<b>Well Name:</b> FULLER 14/11 H3HA FED COM	<b>Well Location:</b> T26S / R29E / SEC 14 / SENE / 32.0430125 / -103.9484352	<b>County or Parish/State:</b> EDDY / NM
<b>Well Number:</b> 1H	<b>Type of Well:</b> OIL WELL	<b>Allottee or Tribe Name:</b>
<b>Lease Number:</b> NMNM011038	<b>Unit or CA Name:</b>	<b>Unit or CA Number:</b>
<b>US Well Number:</b> 3001553430	<b>Operator:</b> MEWBOURNE OIL COMPANY

**Notice of Intent**

**Type of Action:** APD Change

**Procedure Description:** Mewbourne Oil Company request that the following changes be made to the approved APD for the Fuller 14/11 H3HA Fed Com #1H (APD ID: 10400080420)... Change well name from Fuller 14/11 H3HA Fed Com #1H to Fuller 14/11 Fed Com #568H Change BHL from 100' FNL & 330' FEL (Sec 11) to 100' FNL & 440' FEL (Sec 11) Request permission for BOP break testing and offline cementing

Figure 1. Cactus 13 3/8" 5M offline cementing tool. Pressure rating limited by the lesser of 5M tool rating or the 13 3/8" pup joint and casing.

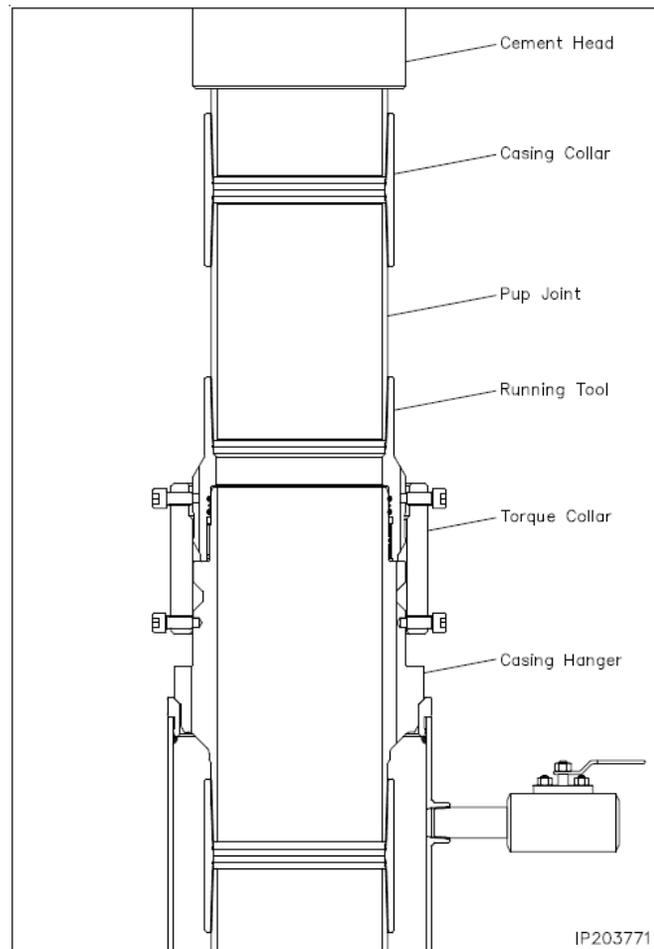
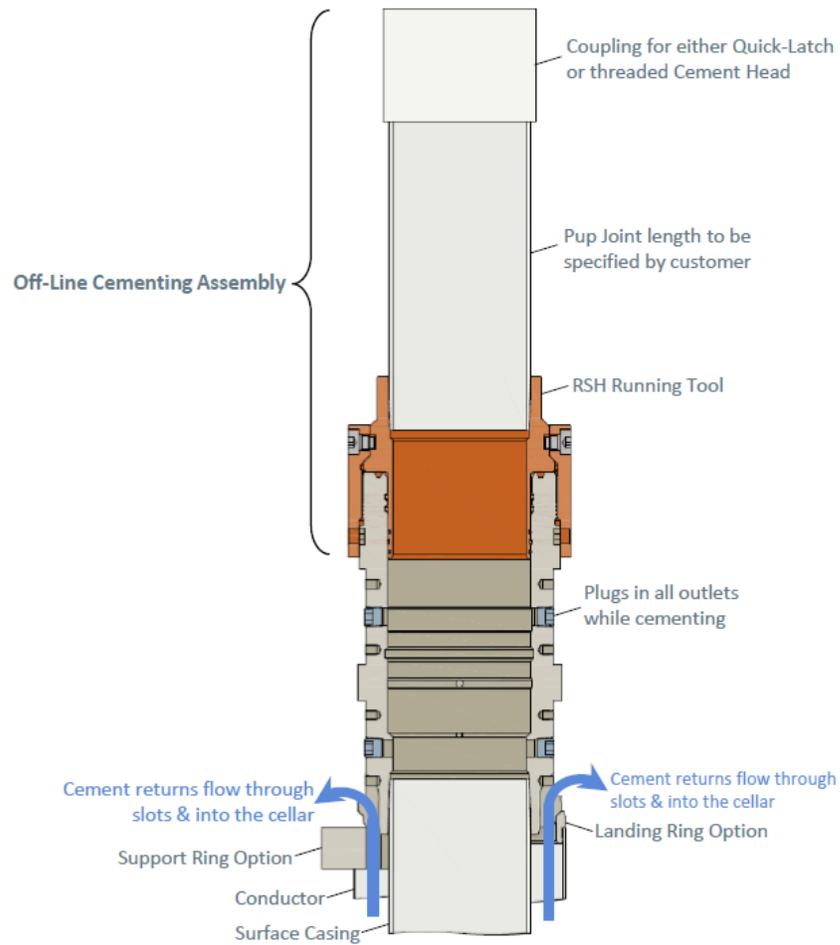
9. Make up offline cement tool with forklift per wellhead manufacturer (Fig. 1 & 2).
10. Make up cement head on top of offline cement tool with forklift.

Figure 3. Cactus 9 5/8" 5M offline cementing tool. Pressure rating limited by the lesser of 5M tool rating or the 9 5/8" pup joint and casing.

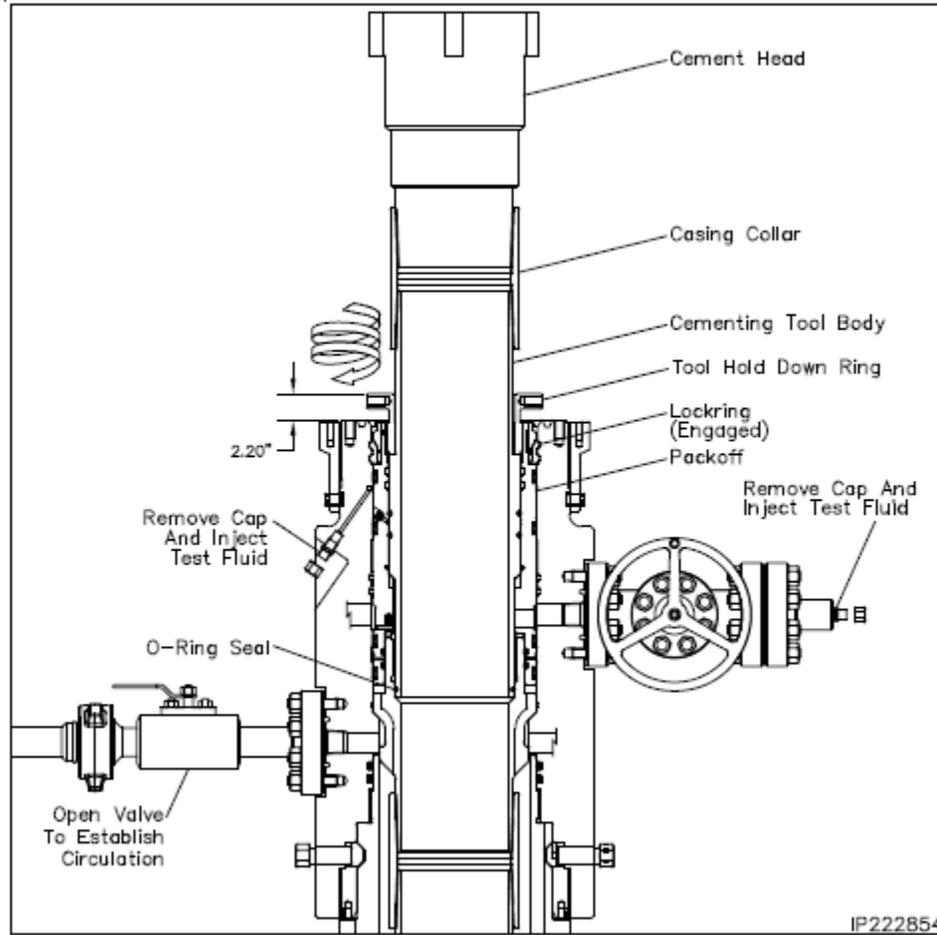
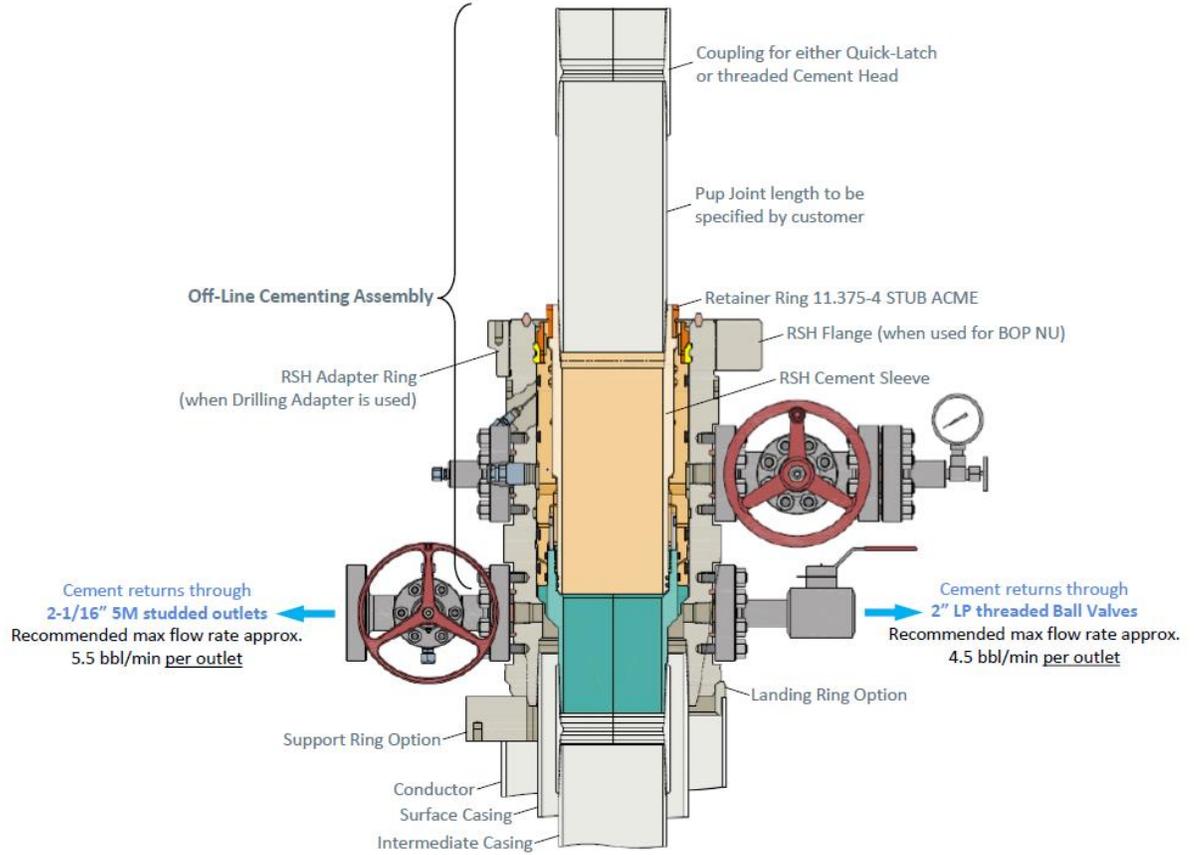
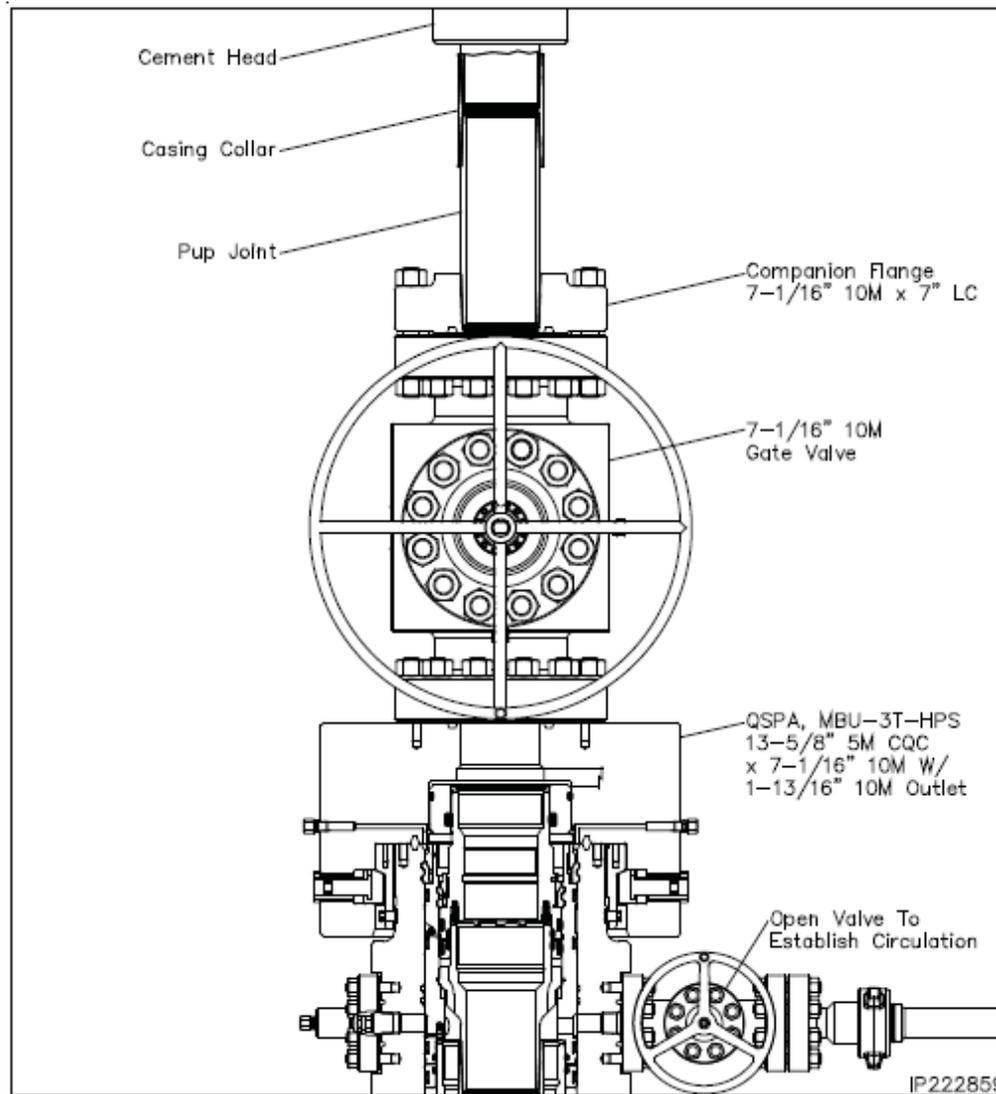
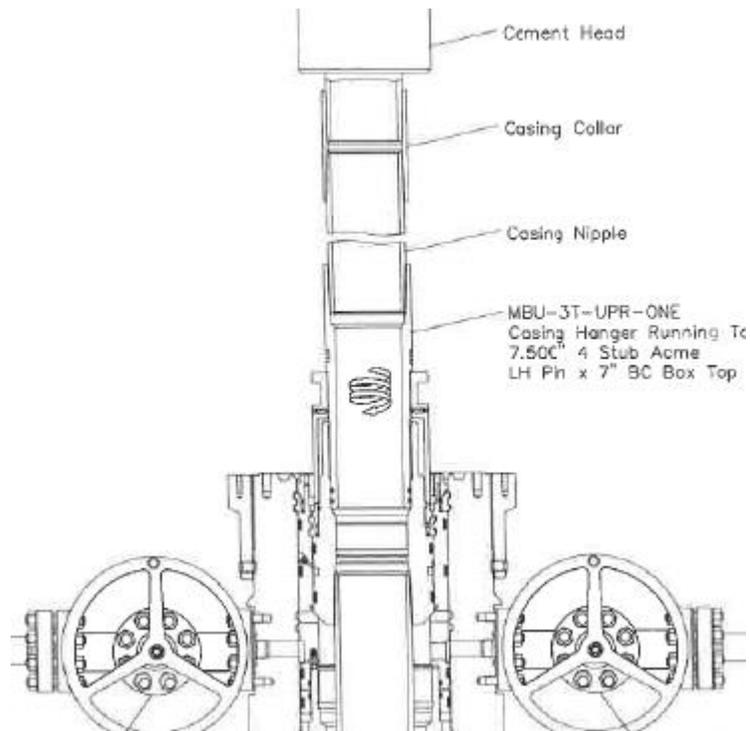
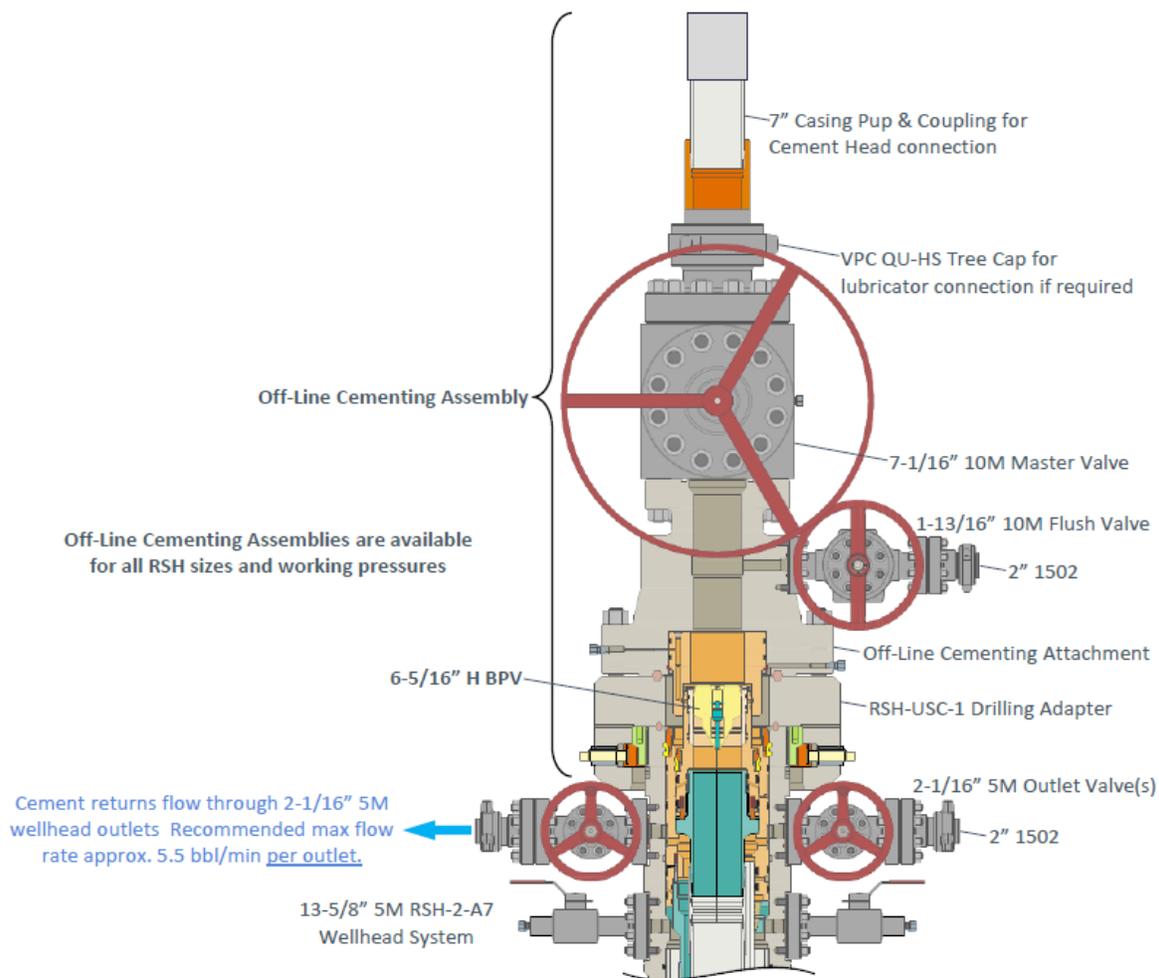
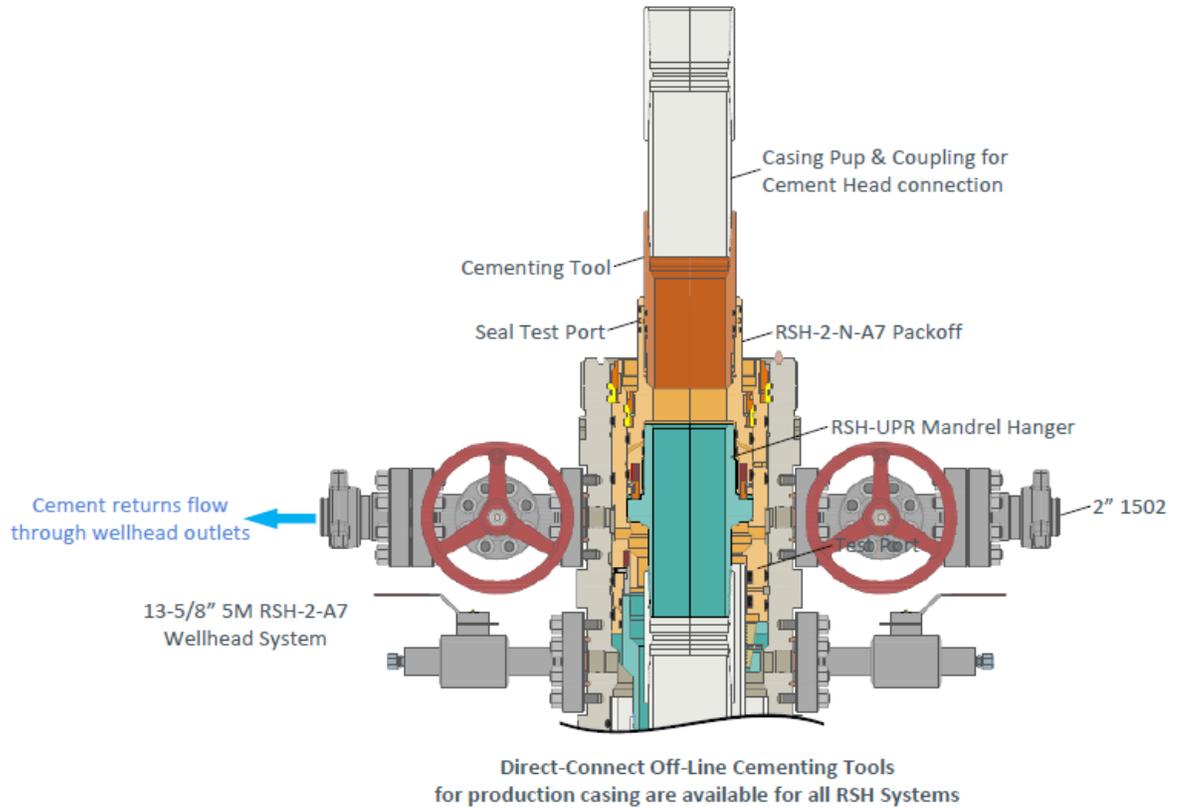
10. Make up offline cement tool using forklift per wellhead manufacturer (Fig. 3 - 8).
11. Make up cement head on top of offline cement tool.
12. Commence cement operations.

Figure 1. BOP diagram

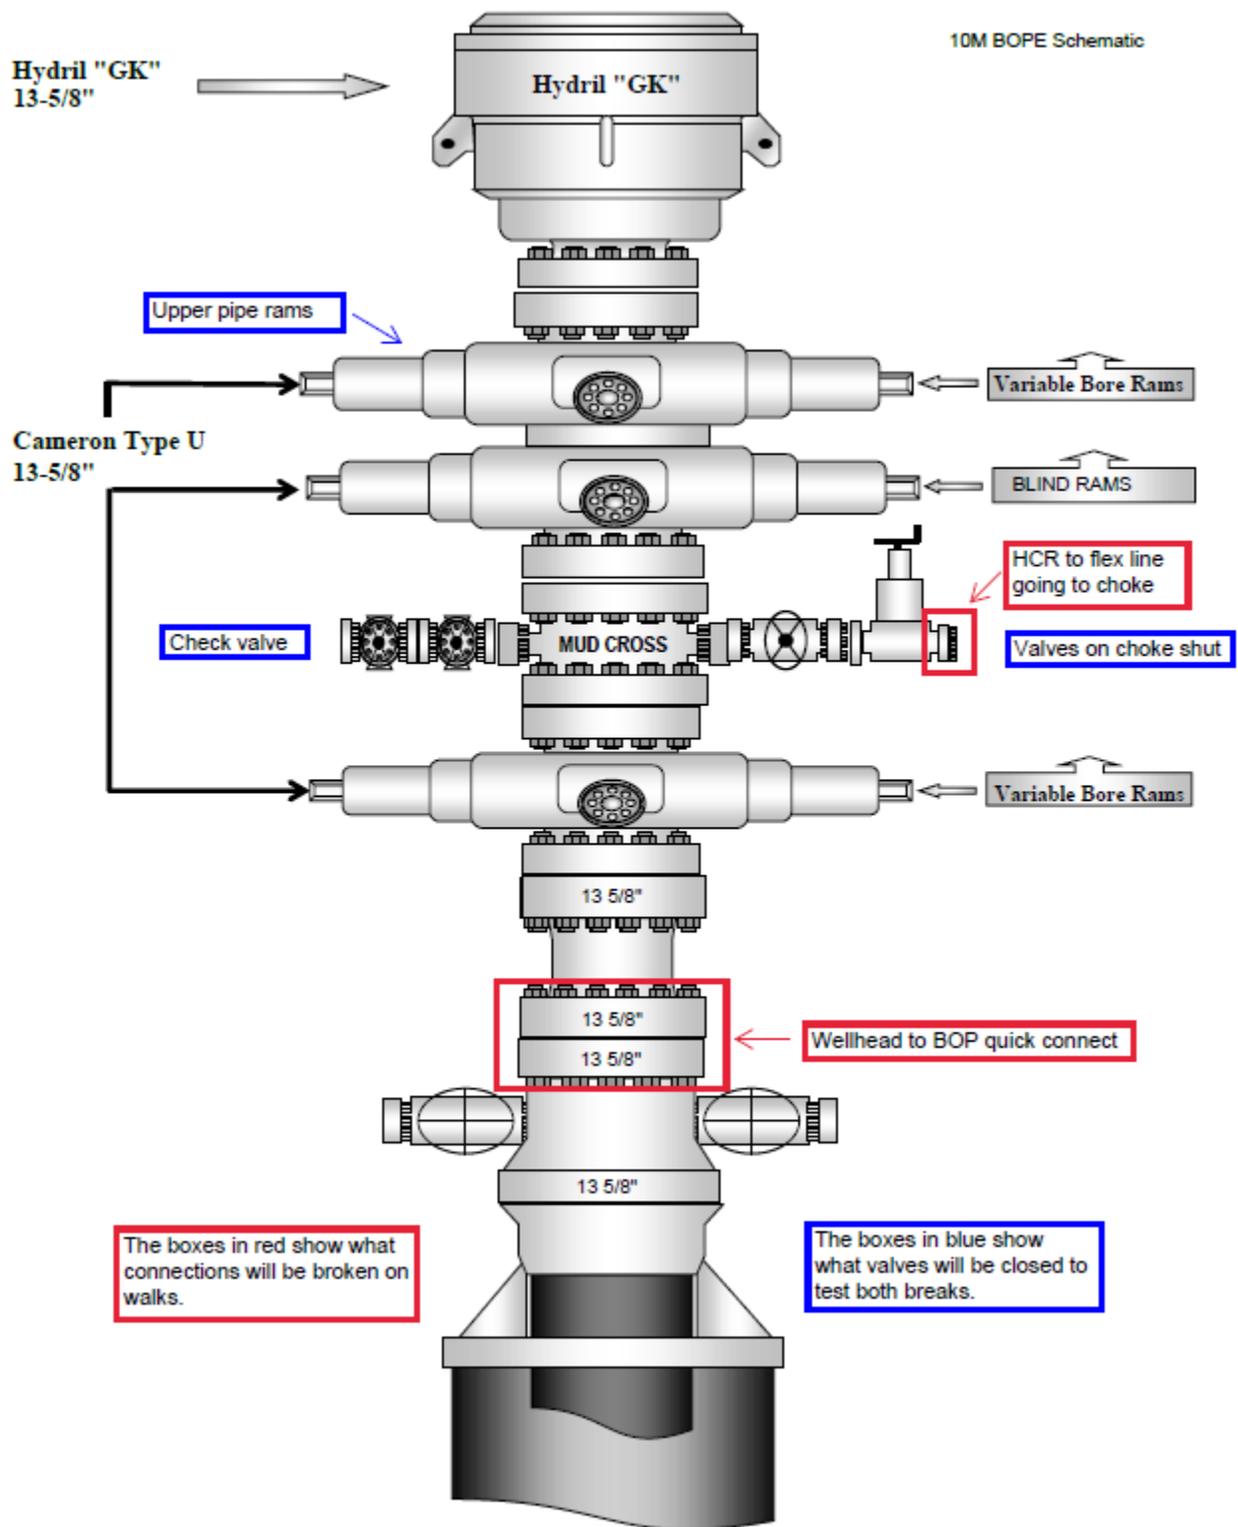
2. After the well section is secured and the well is confirmed to be static, the BOP will be disconnected from the wellhead and walked with the rig to another well on the pad. Two breaks on the BOPE will be made (Fig. 1).

9. A test will then be conducted against the upper pipe rams and choke, testing both breaks (Fig. 1 & 2).
10. The test will be held at 250 psi low and to the high value submitted in the APD, not to exceed 5000 psi.

Figure 5. Cactus 5M wellhead with BOP quick connect

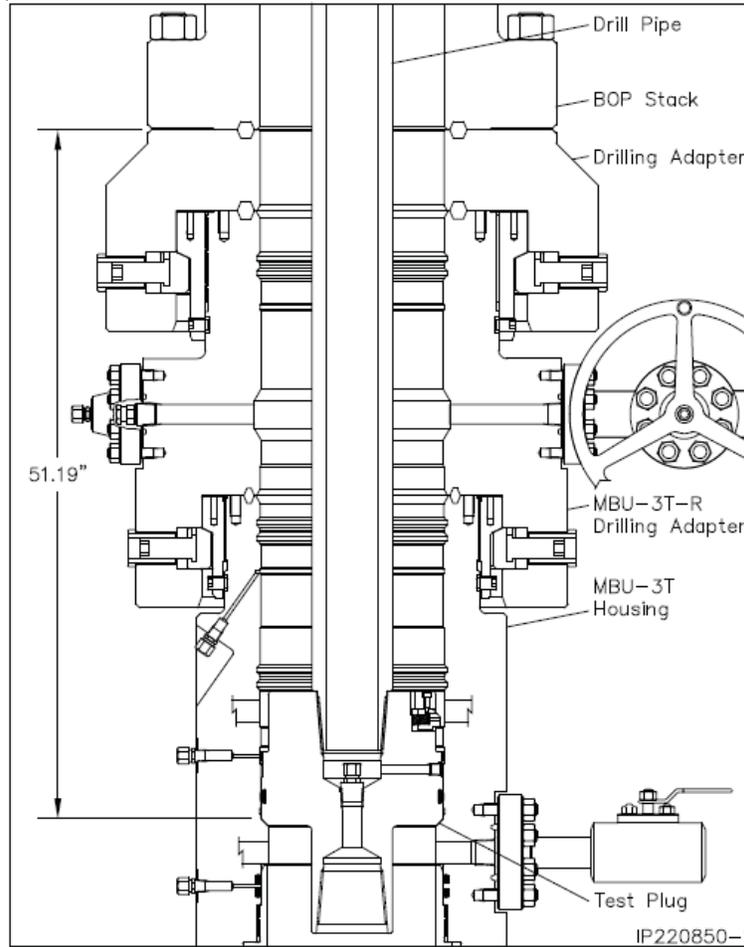
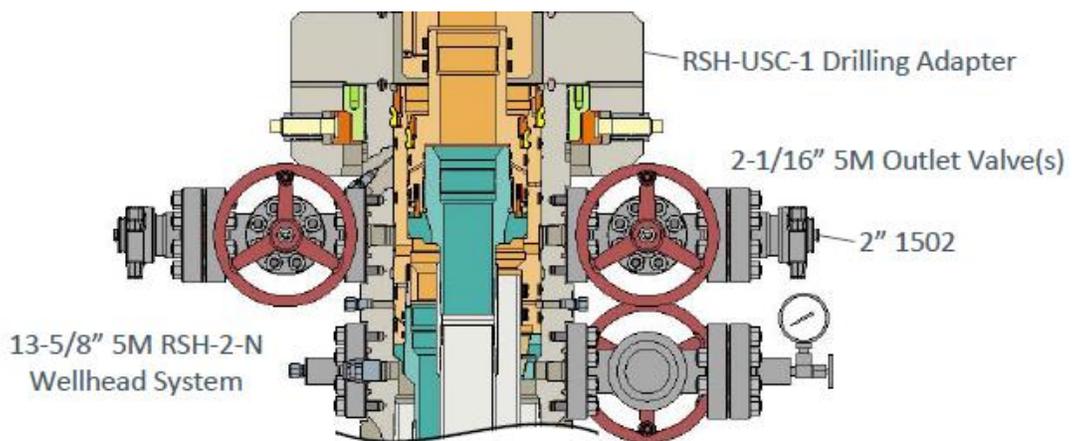
- Connection between the flex line and the HCR valve
  - Connection between the wellhead and the BOP quick connect (Fig. 5 & 6).
3. A capping flange will be installed after cementing per wellhead vendor procedure & casing pressure will be monitored via wellhead valve.
